# 7-ELEVEN

STORE #38421

STATE HIGHWAY NO. 66 & WILLOW BEND  
ROCKWALL, TEXAS 75087

"RECORD DRAWINGS"  
These drawings have been revised to show changes during the construction process reported by the contractor to Evolving Texas and considered significant. This drawing is not guaranteed to be "As Built", but is based on visual inspection and the information available and provided to Evolving Texas  
Date: 10/9/2019 By: *Samantha D. Renz*

# Demolition Plan

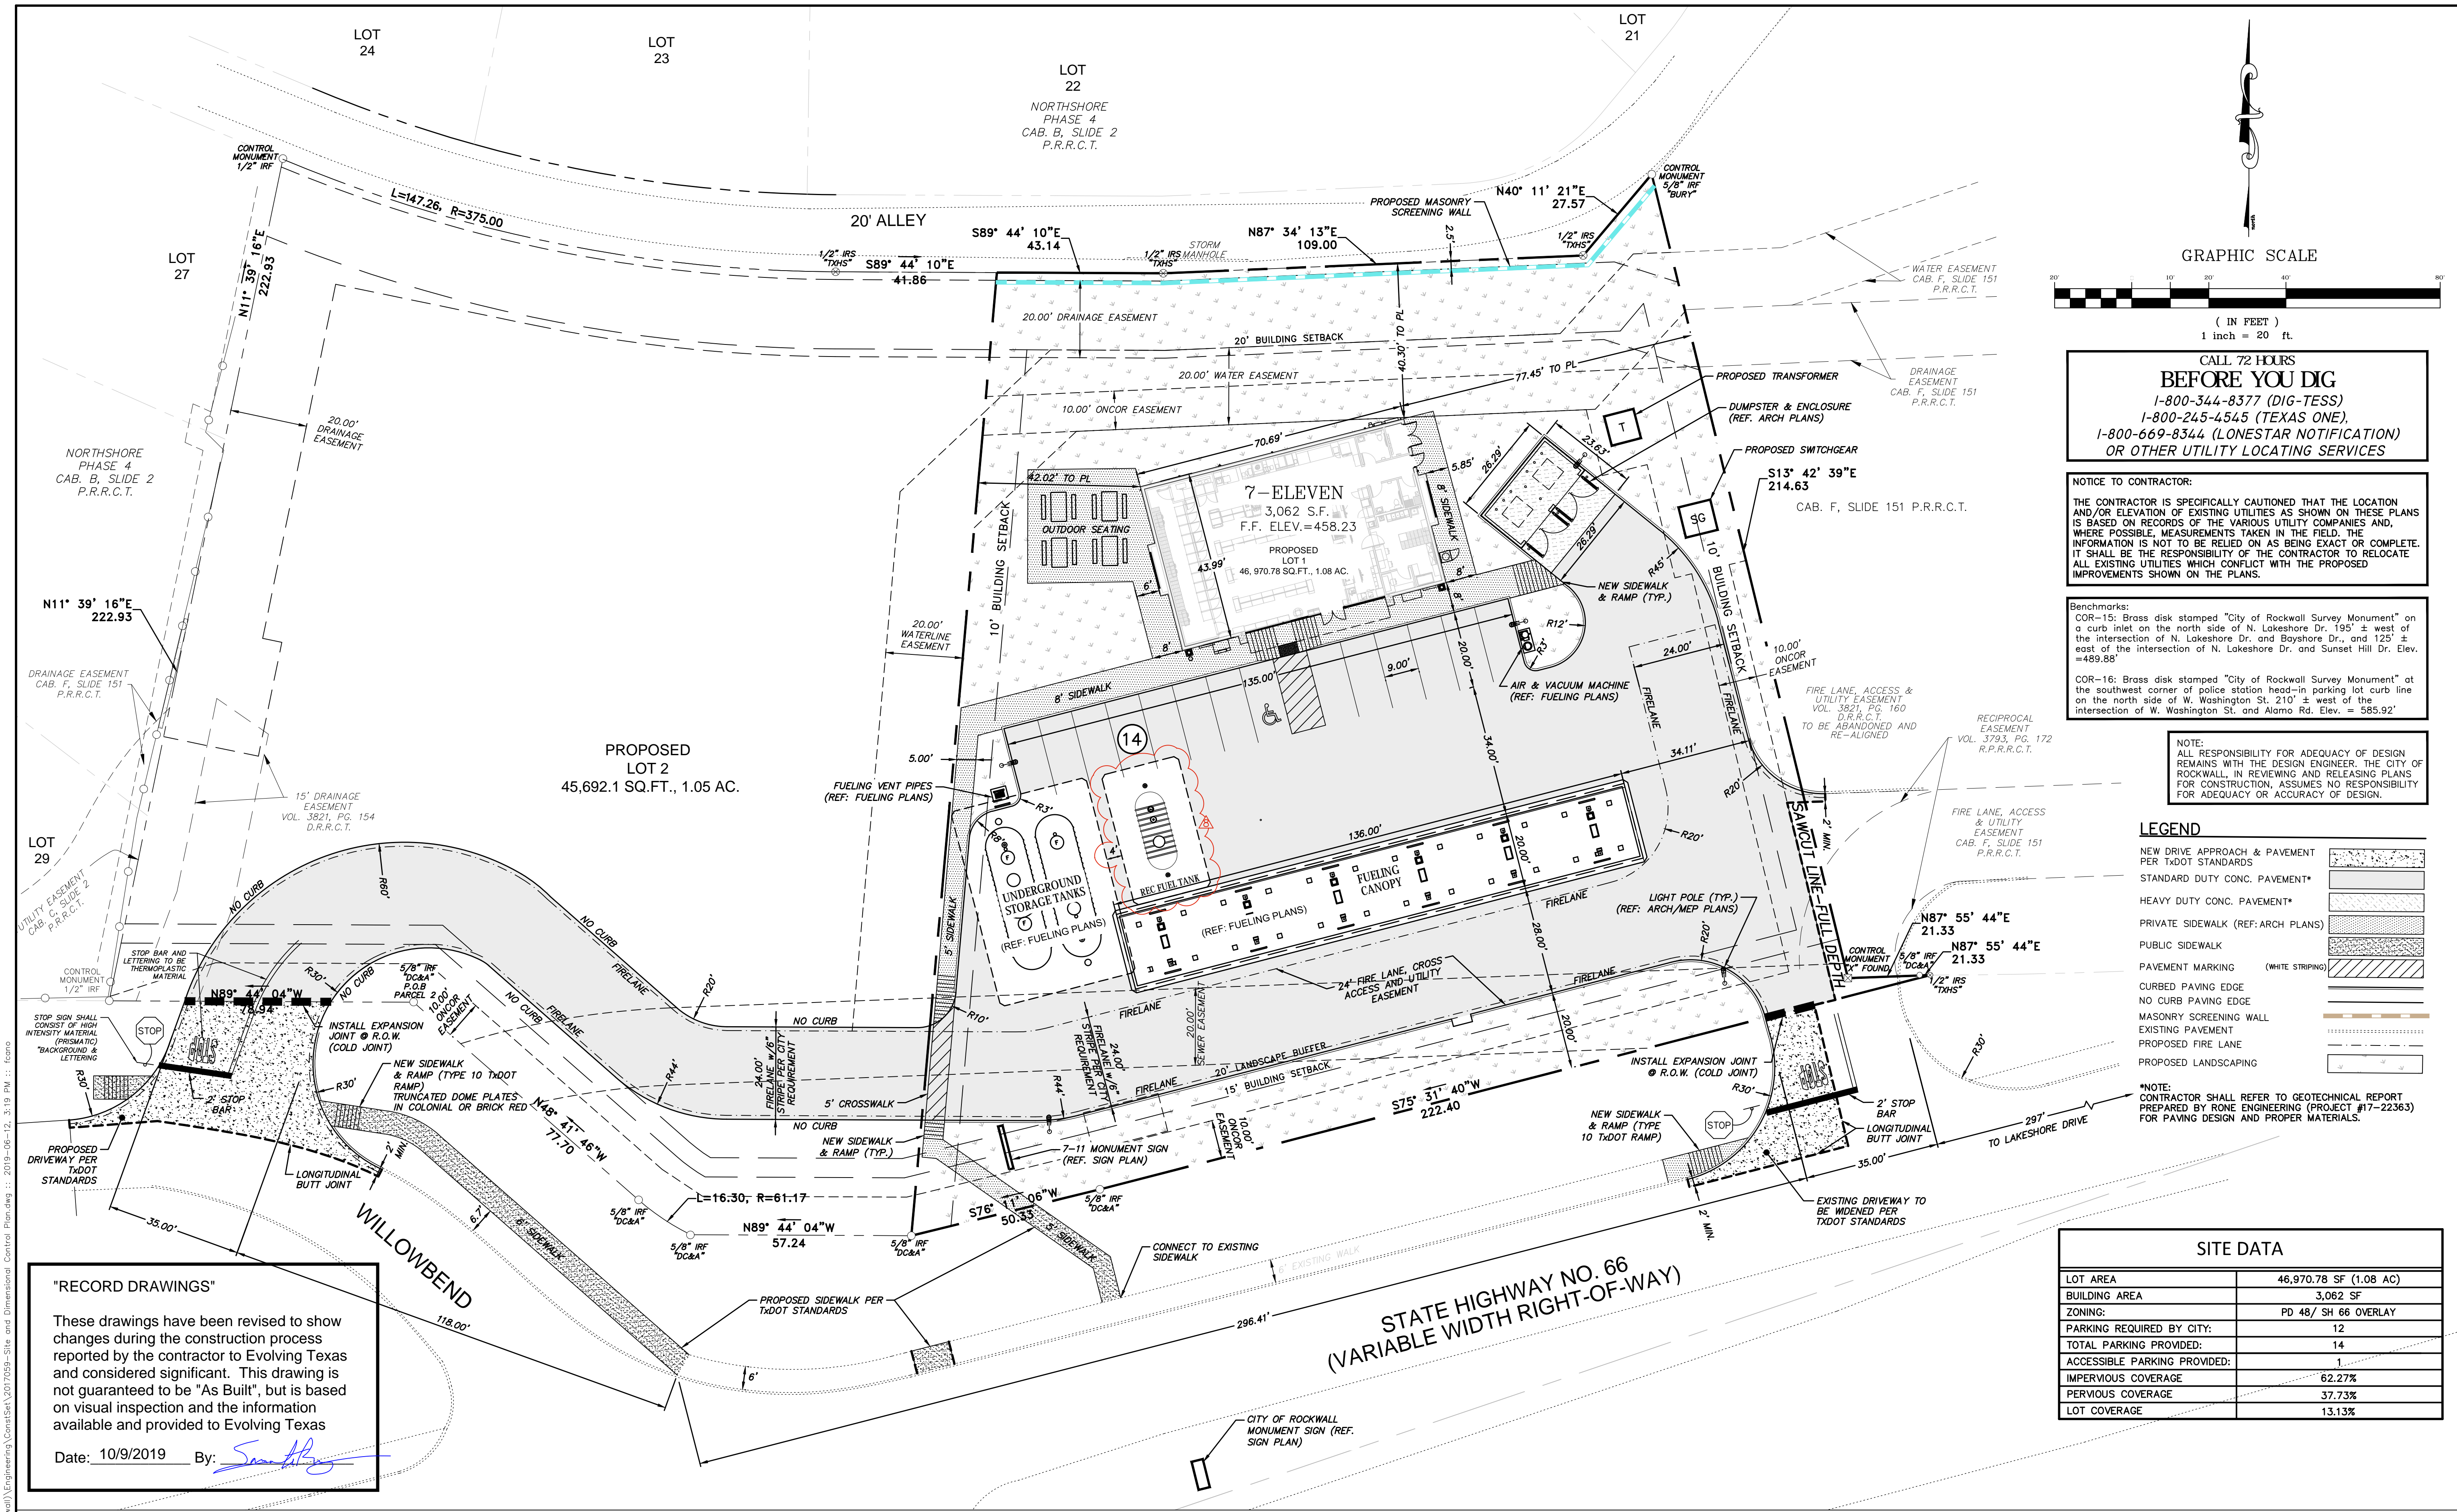
NO.	DATE	REVISIONS	COMMENTS
1	1/21/19	Remove tree that is in contact with new above ground line and sidewalk.

Site Plan & Dimension Control

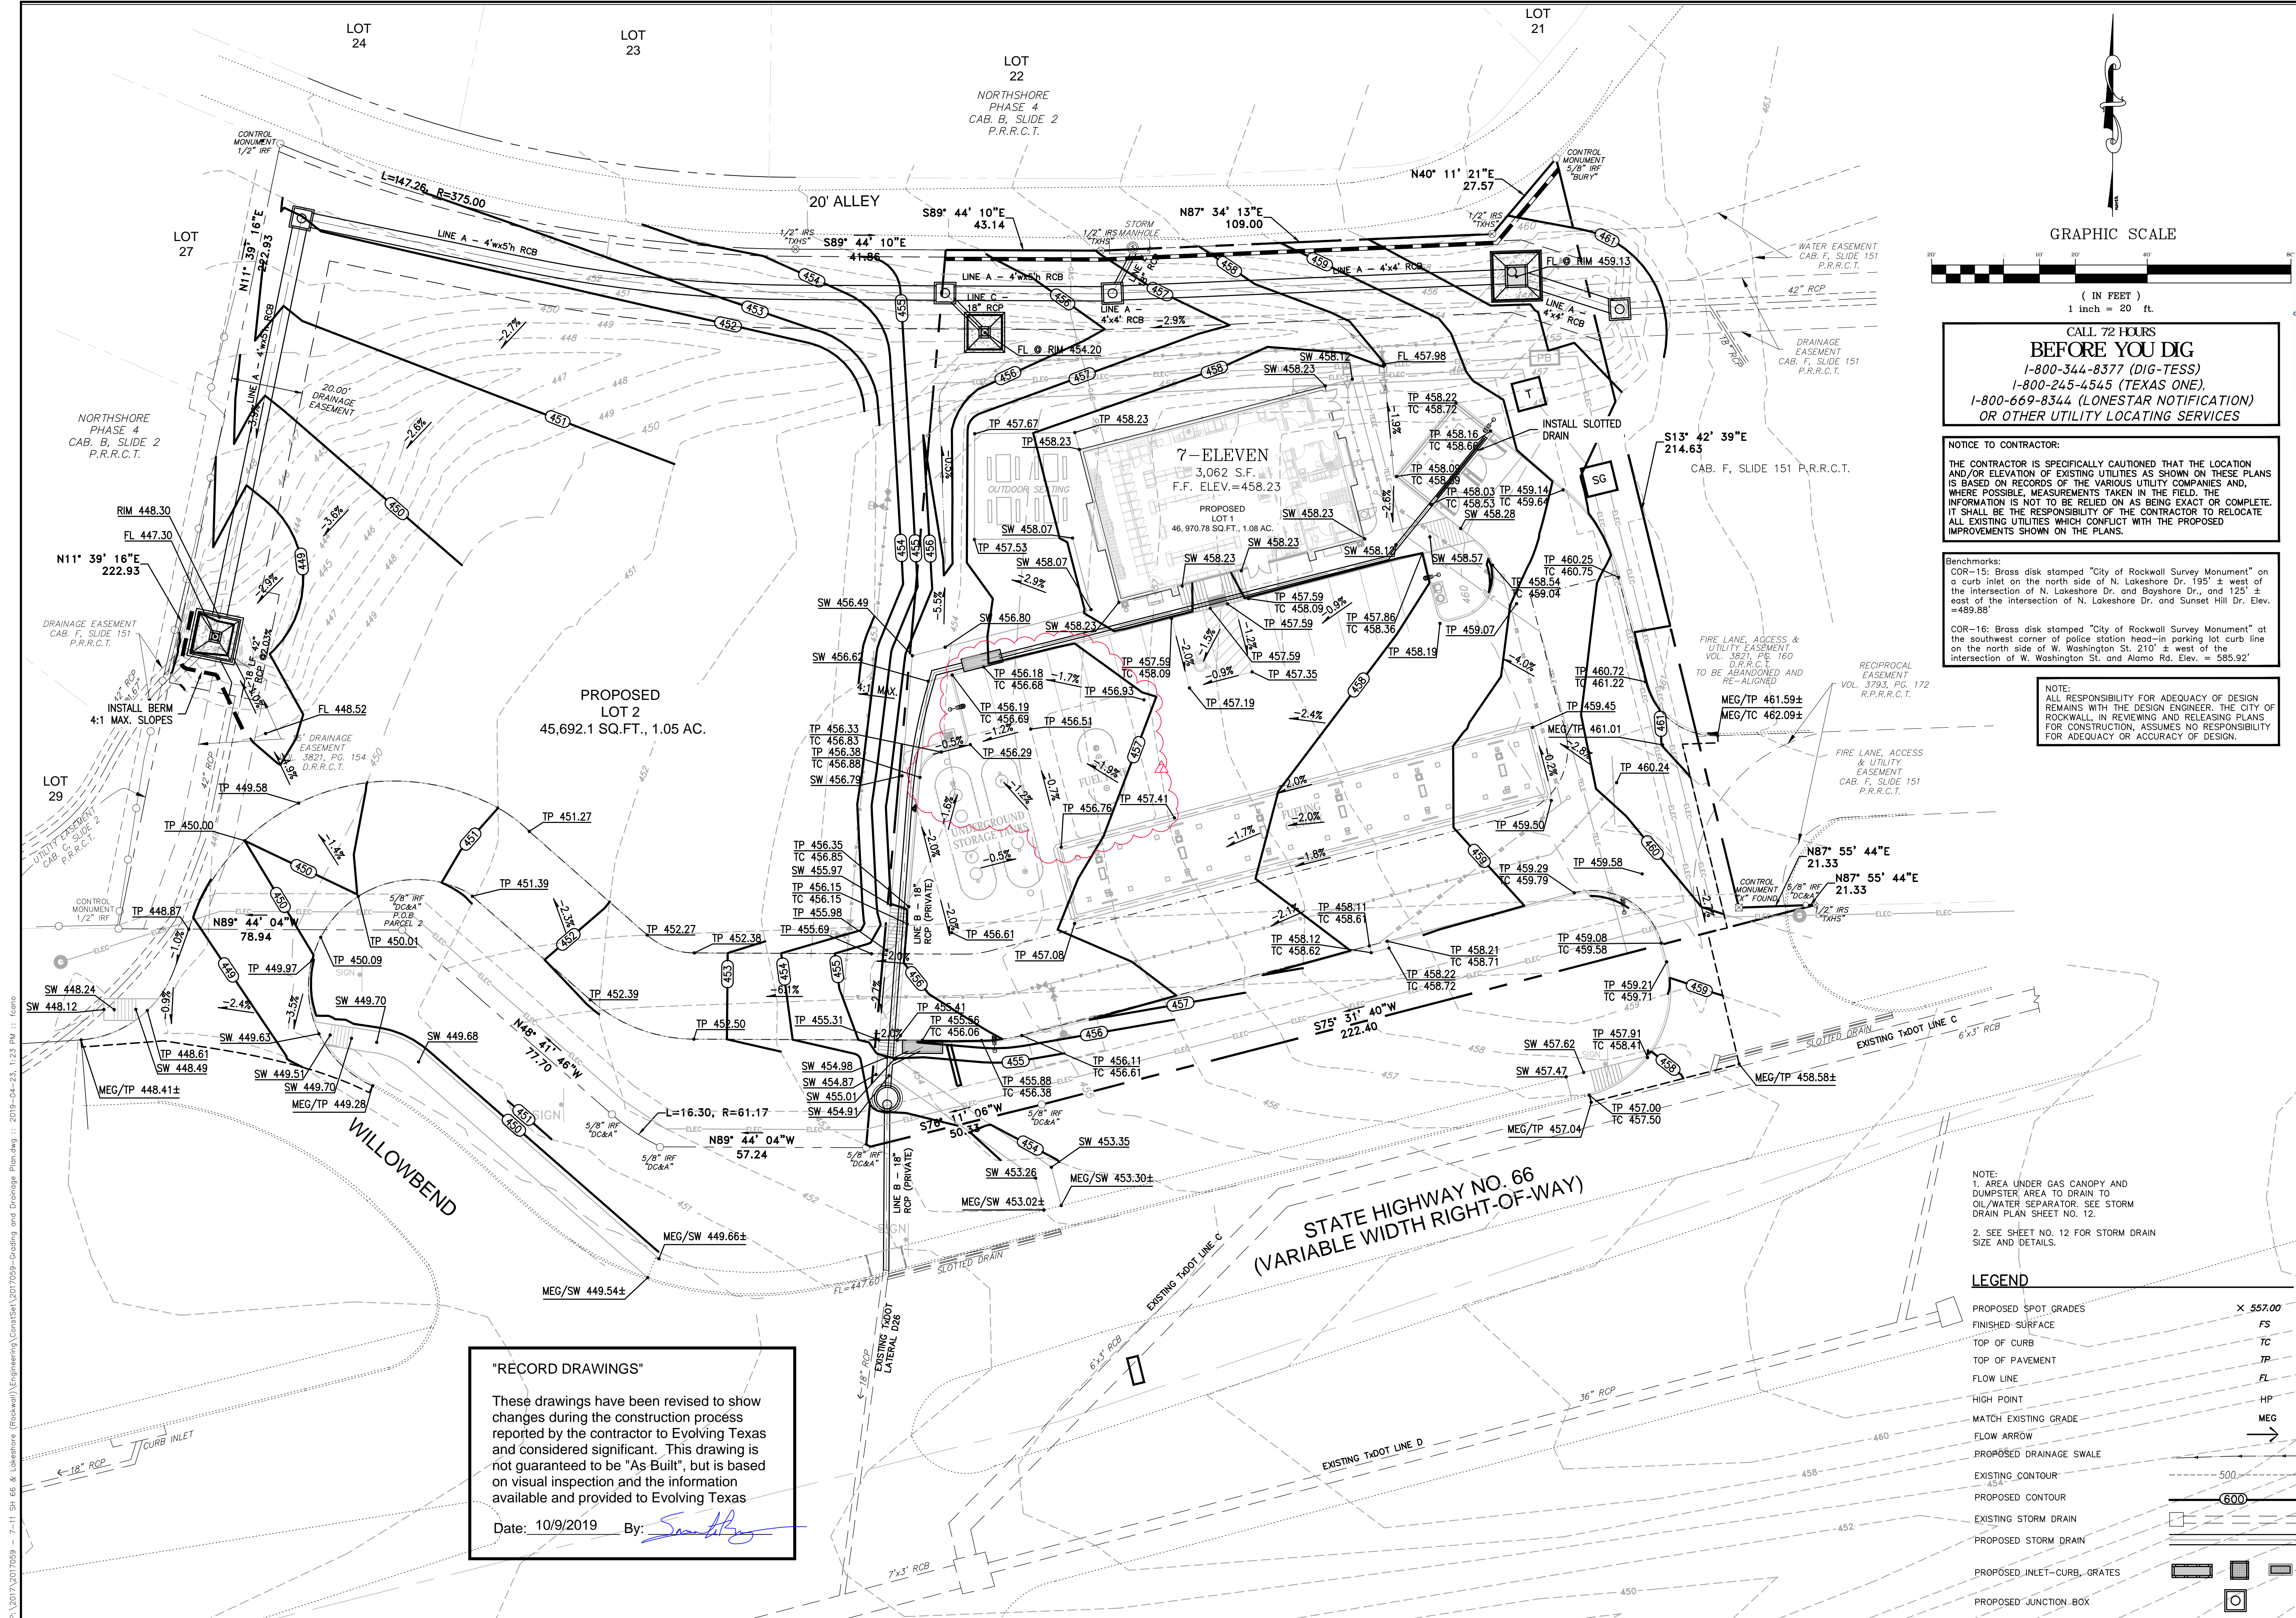
NO.	DATE	COMMENTS
1	1/21/19	Added Drive, underground transformer, switchgear and easements / shifted
2	2/25/19	Added underground tanks 5' feet from building / added 10' sidewalk
3	4/07/19	Shifted screen wall to be 2.5' from property line
4	4/05/19	Added 1" of concrete to pavement sections & eliminated live stabilization
5	4/18/19	Added REC for underground tank / revised standard duty pavement limits
6	6/11/19	Revised REC for underground tank / revised standard duty pavement limits

**Utility Plan**

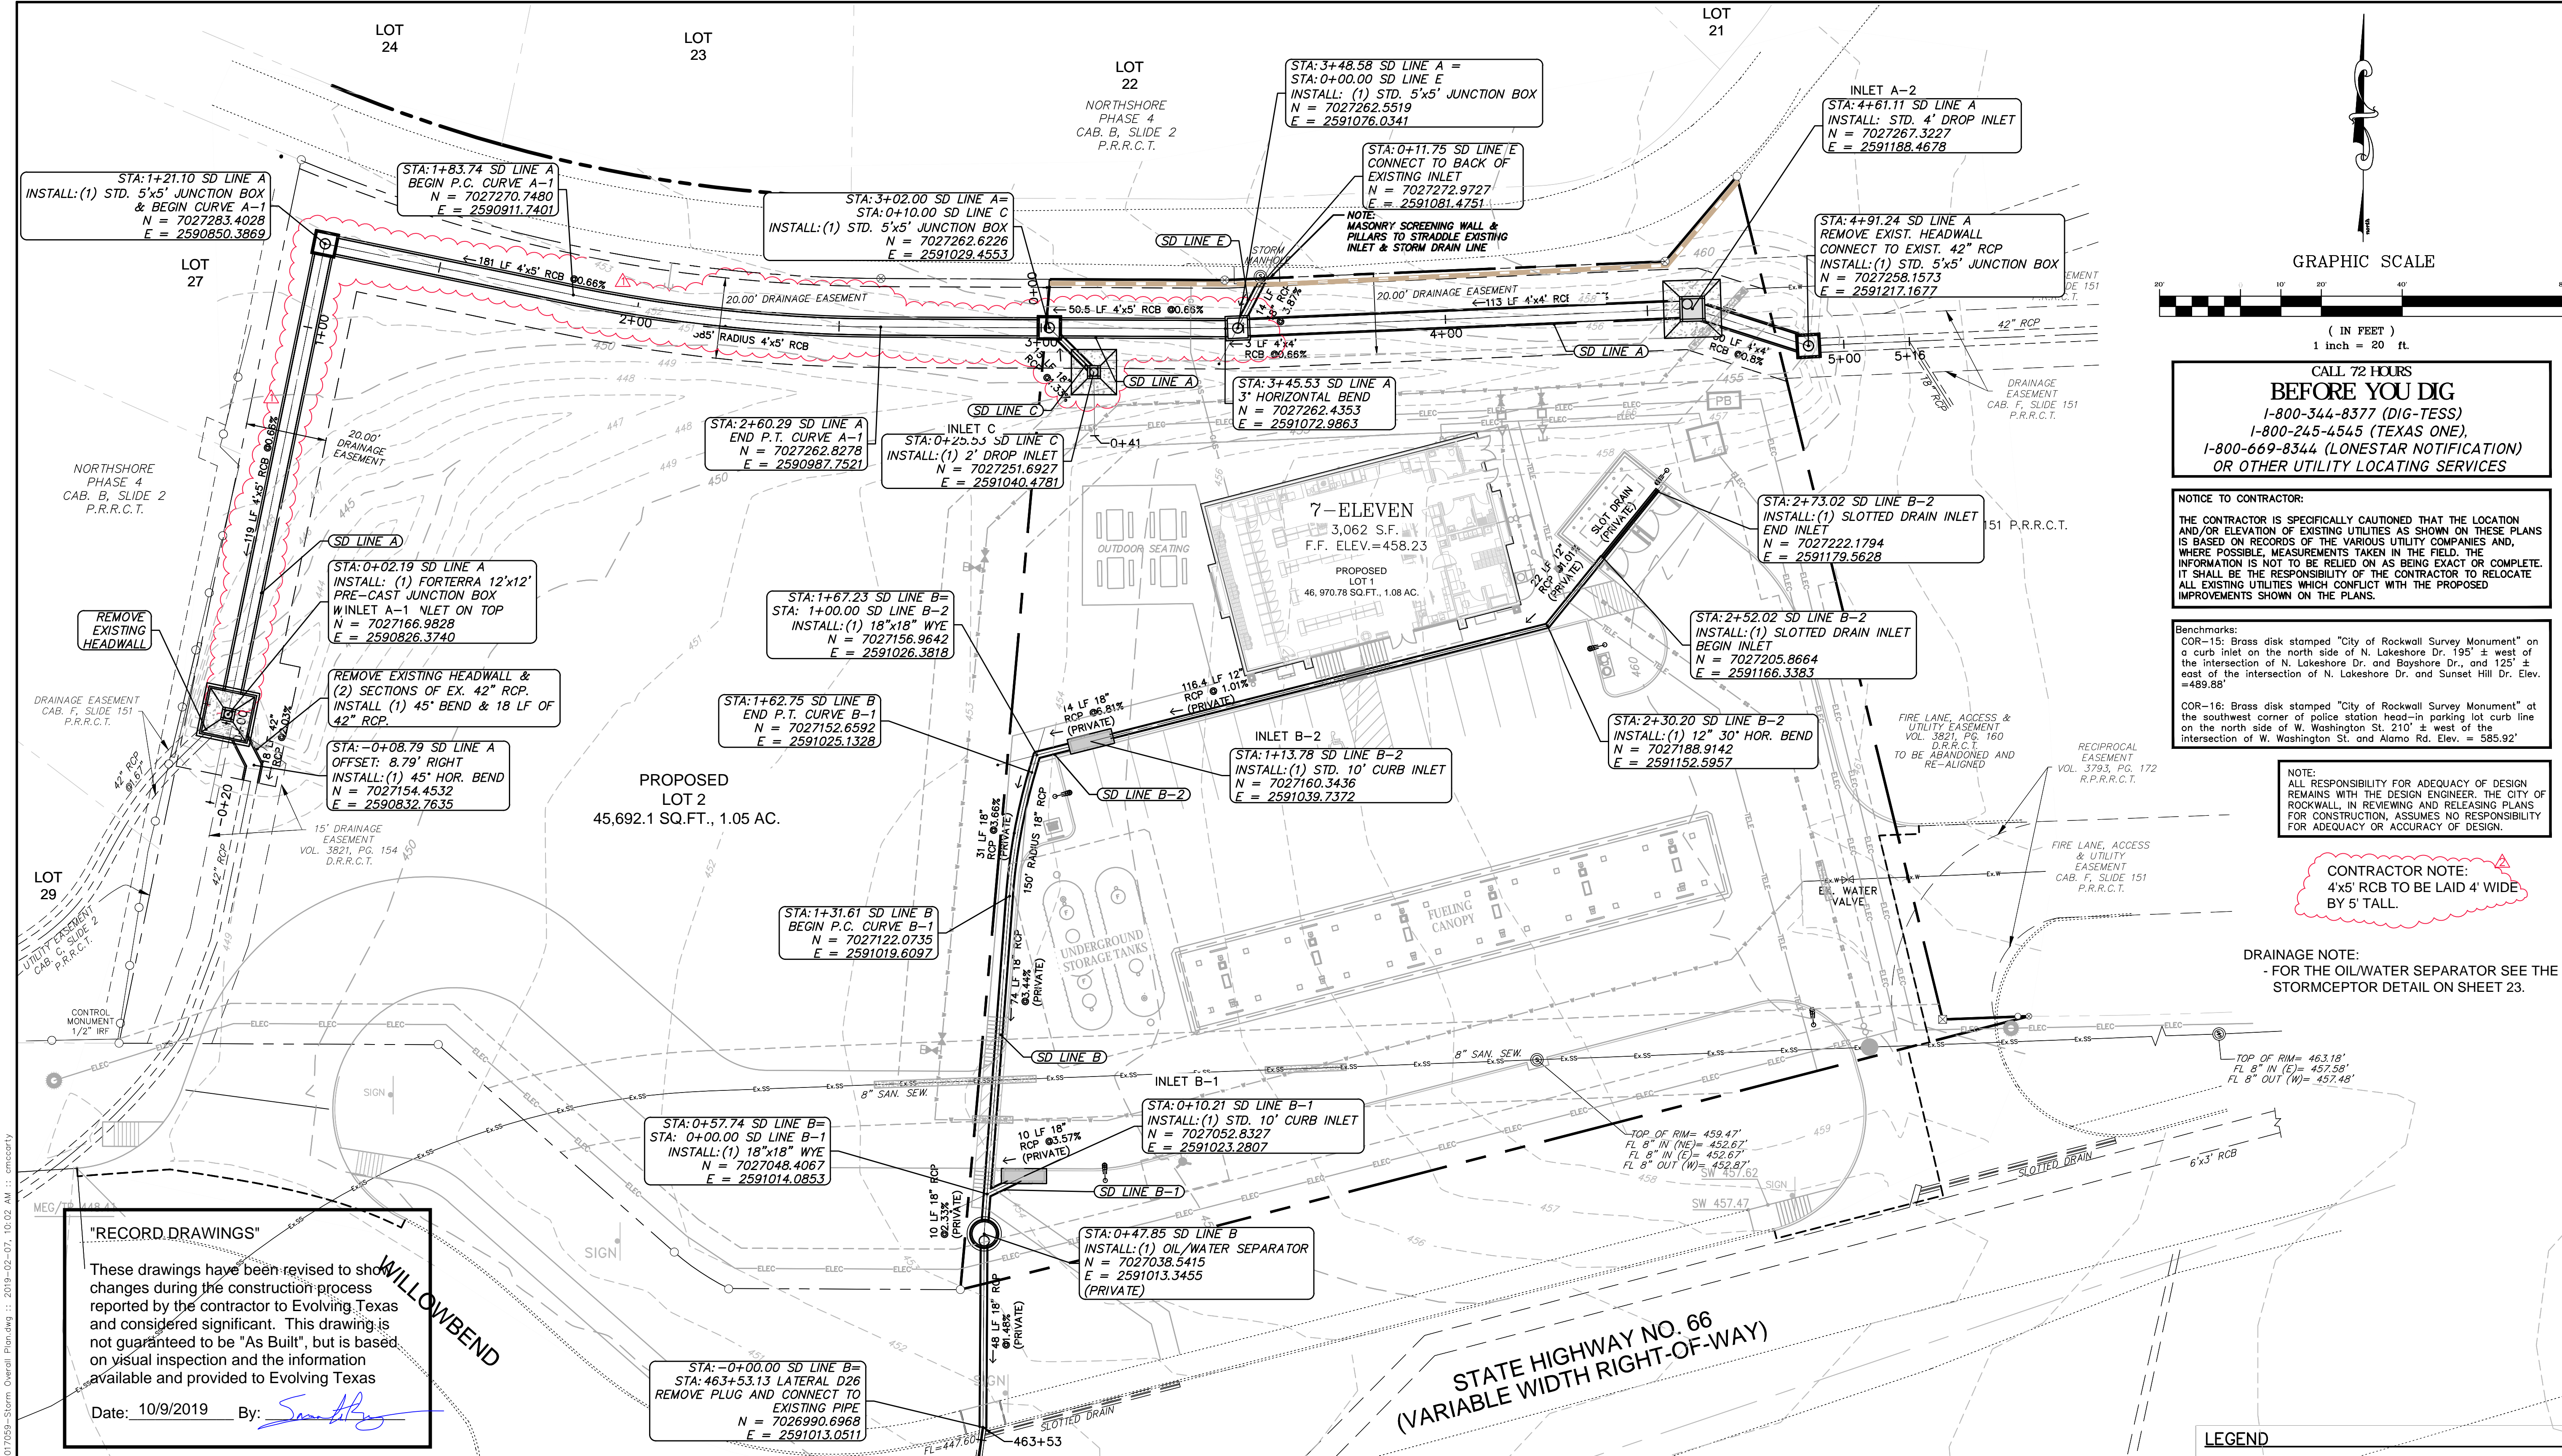
NO.	DATE	COMMENTS
1	1/21/19	Added DCA, underground utility, fire, transformer, telephone and sewer lines. Revised private sanitary sewer alignment to connect to existing manhole.
2	3/6/19	Revised private sanitary sewer alignment to connect to existing manhole. Revised to be located under 7' finished concrete easement from lot 29.
